Nebraska Public Power District
Cooper Nuclear Station

**DEMONSTRATION OF COMPLIANCE
WITH
10 CFR 50, APPENDIX I
SUPPLEMENT**

June 27, 1977

Demonstration of Compliance
with
10CFR50, Appendix I
Supplement

FIGURE 6.2
WIND FREQUENCY DISTRIBUTION
COOPER NUCLEAR STATION
NEBRASKA PUBLIC POWER DISTRICT

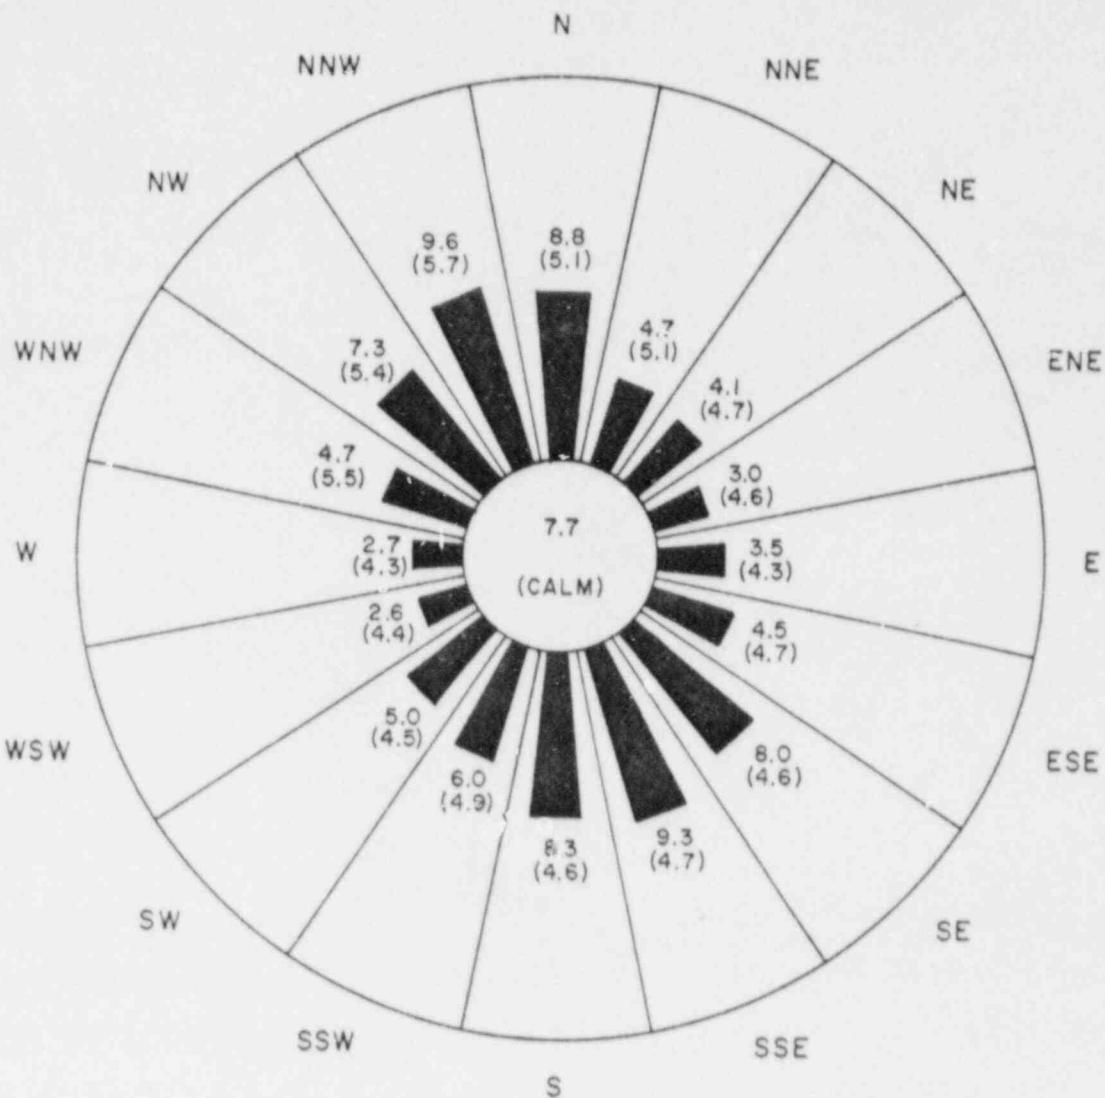
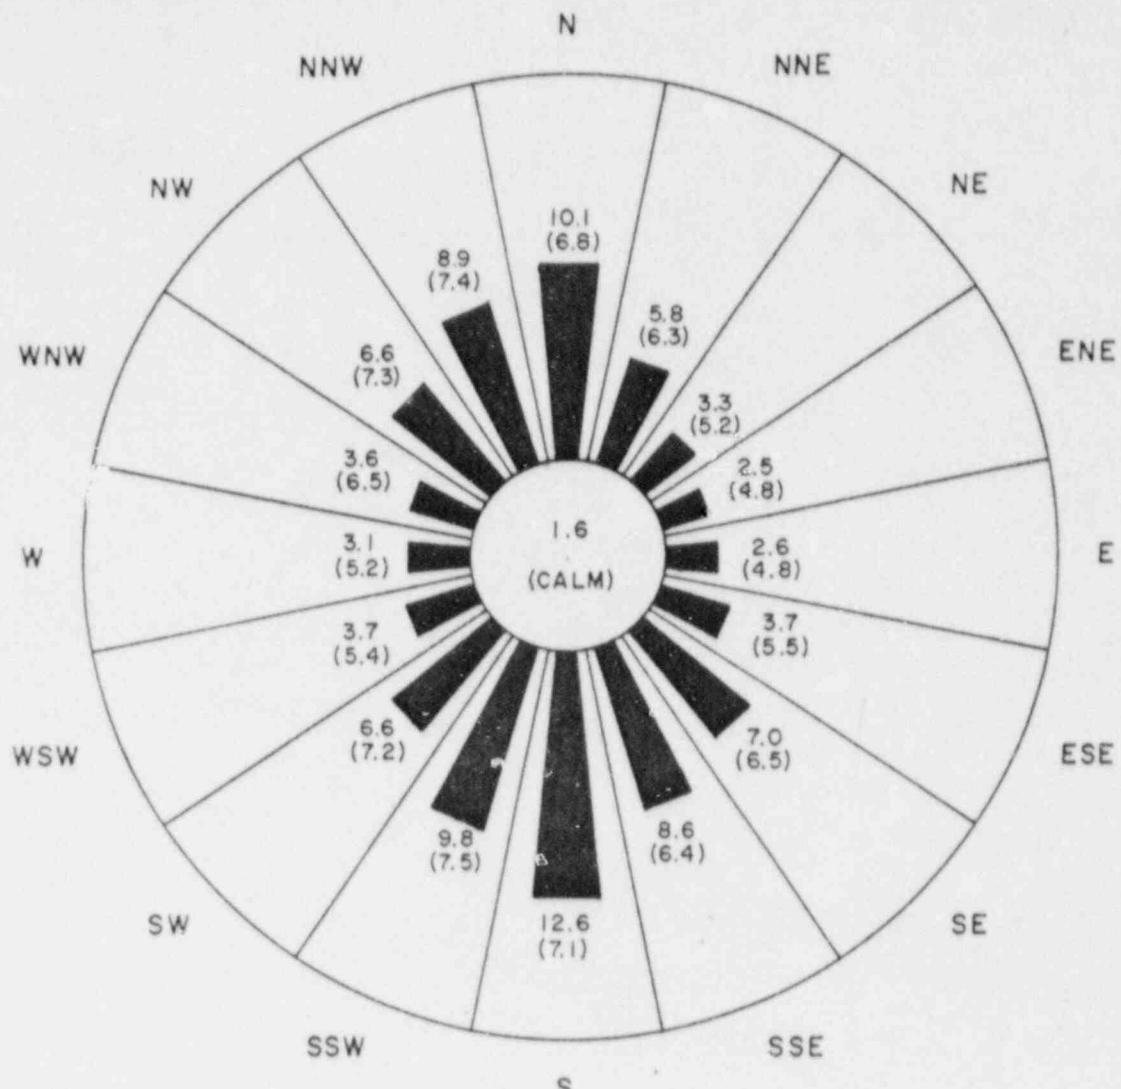
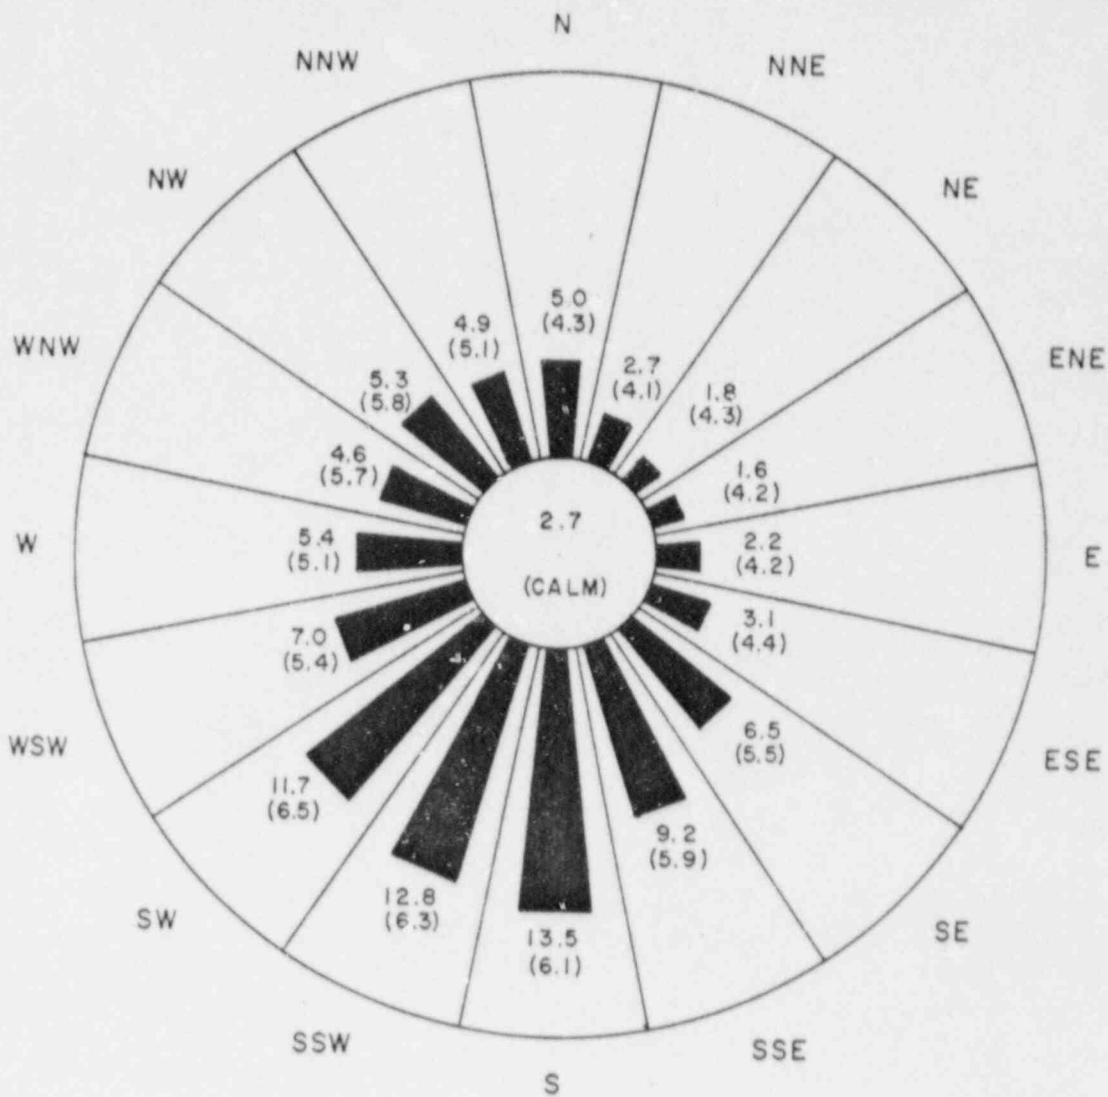
QUESTION 6

The wide, low valley of the Missouri River on which the Cooper Nuclear Station is located would not be expected to produce the valley drainage winds under stable atmospheric conditions at night for which the terrain correction factor of 5 applies. The reason for the frequency

distribution that might indicate a valley bimodal flow characteristics is that this is the normal climatological wind frequency characteristic of the Nebraska-Missouri region. Figures 6.1 and 6.2 show the annual wind roses for Lincoln, Nebraska, and the 96.93-meter-level of the Cooper Nuclear wind system, respectively. It can be seen that Lincoln, located completely out of a valley but within the same climatological region, has very similar wind distributions.

To further help in understanding the flow characteristics of the Cooper Nuclear Station, a stability wind rose of the 96.93-meter-level using both F and G stability classes, those that would occur during valley drainage wind periods, was derived and shown on Figure 6.3. It can be seen that, although there is a definite peak in the normal south to southwest flows, there is also a very definite lack of a north sector flow. The latter flows would be those of the drainage flow pattern. There is, therefore, no support of a bimodal flow pattern at the Cooper Nuclear Station.

FIGURE 7.2
GENERAL PROFILE VIEW
COOPER NUCLEAR STATION
NEBRASKA PUBLIC POWER DISTRICT

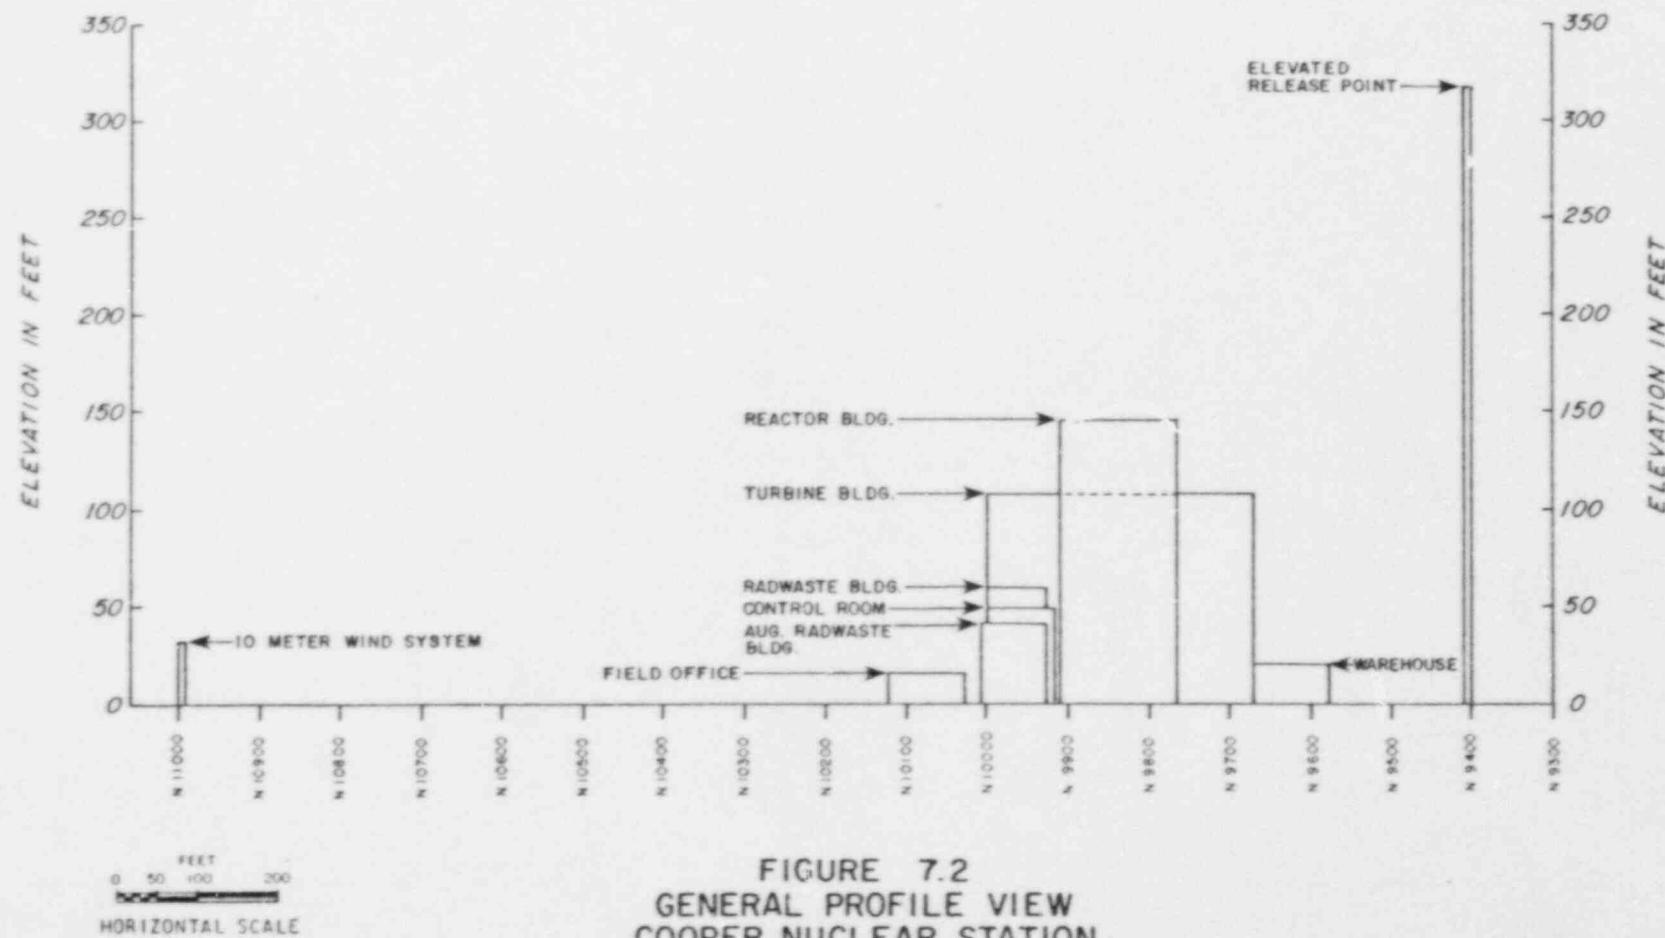
From the discussion of the location of the meteorological instrumentation provided on page 5-45, and the information provided in Figure 4.1, it is not clear that current meteorological measurements at the Cooper site are representative of conditions away from the plant structures. The lower level sensors could be significantly influenced by plant structures resulting in perturbed wind flow characteristics and non-representative measurements of vertical temperature gradient.

- a) Discuss the location of the meteorological instrumentation in more detail, considering particularly the presence of nearby structures that could influence wind and temperature measurements, and indicate why this data collection program is considered to provide representative measurements.
- b) Provide a figure showing the location of the meteorological sensors with respect to elevations of nearby structures.

- a) The 10.67-meter-level instruments are not located on the Elevated Release Point tower but are located on a pole as shown on Figures 7.1 and 7.2 to be approximately 1250 feet southwest of the Reactor Building, which is 146 feet above the plant base level of 903 feet MSL. This distance is within the generally accepted rule-of-thumb, which says that wind flow at a distance downwind that is
